Flat 5 Ventana Court, 61A Endell Street 2021/5104/P

| Delegated Report (Members Briefing) | | Analysis sheet | Expiry Date: | 24/12/2021 |
| Erection of a single storey extension on the second floor roof terrace, partial demolition of the roof at third floor for a new roof terrace; installation of stairwell roof balcony and terrace south wall. | | | | |

Image 1. Showing the proposed design on the left with the existing elevation on the right.

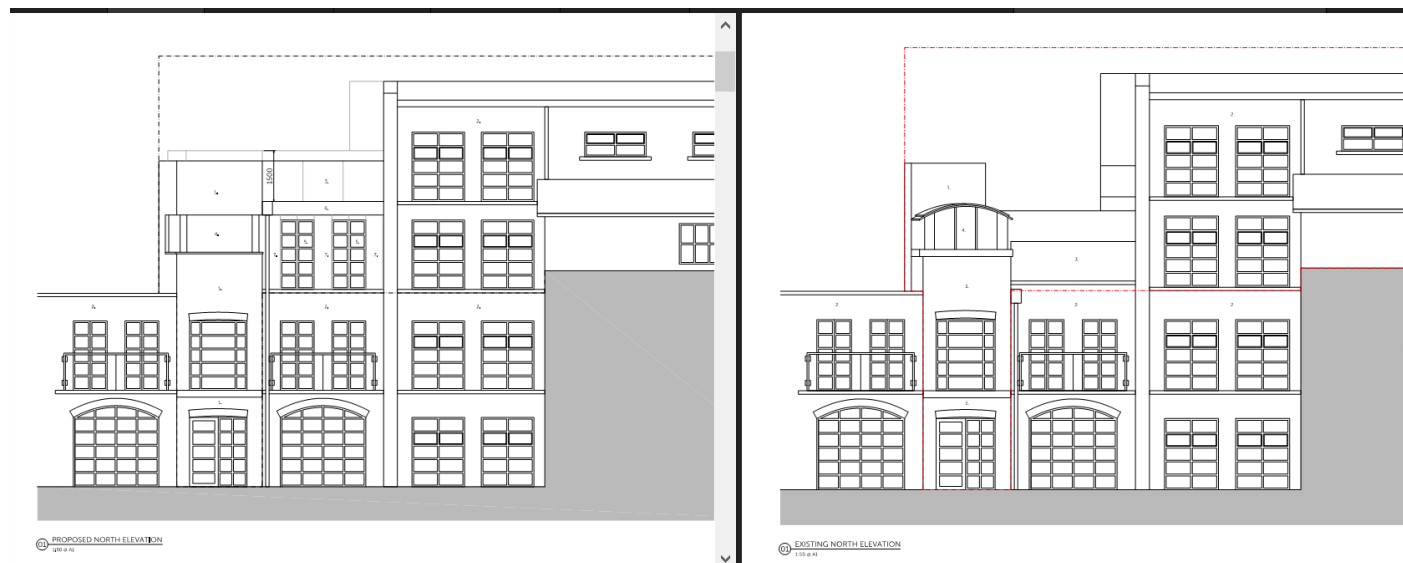
sits at two/three stories. The roof extension would be designed with characteristic elements of the original building with simpler and cohesive façade/ fenestration treatment. The proposed revised elevation would sit comfortably within its setting and the window openings proposed would introduce a hierarchy to the façade that matches the design and location of the windows below. Thus, the roof extension would preserve the architectural design of the host building. The proposed seam wall cladding would match the design of the existing roof in response to the original building characteristics.

- 4.7. The proposed Crittall framed windows would match the existing and the glazing element over the stairwell that would be retained in a new form. the new roof terrace on the flat roof of the proposed extension would be a replacement of the existing terrace at second floor. The proposed roof terrace would include glass balustrade similar in design to the balustrade of the Juliet balconies at first floor level. Within this context the proposal would be of an appropriate design and would not cause visual harm to the design or the appearance to the host building.
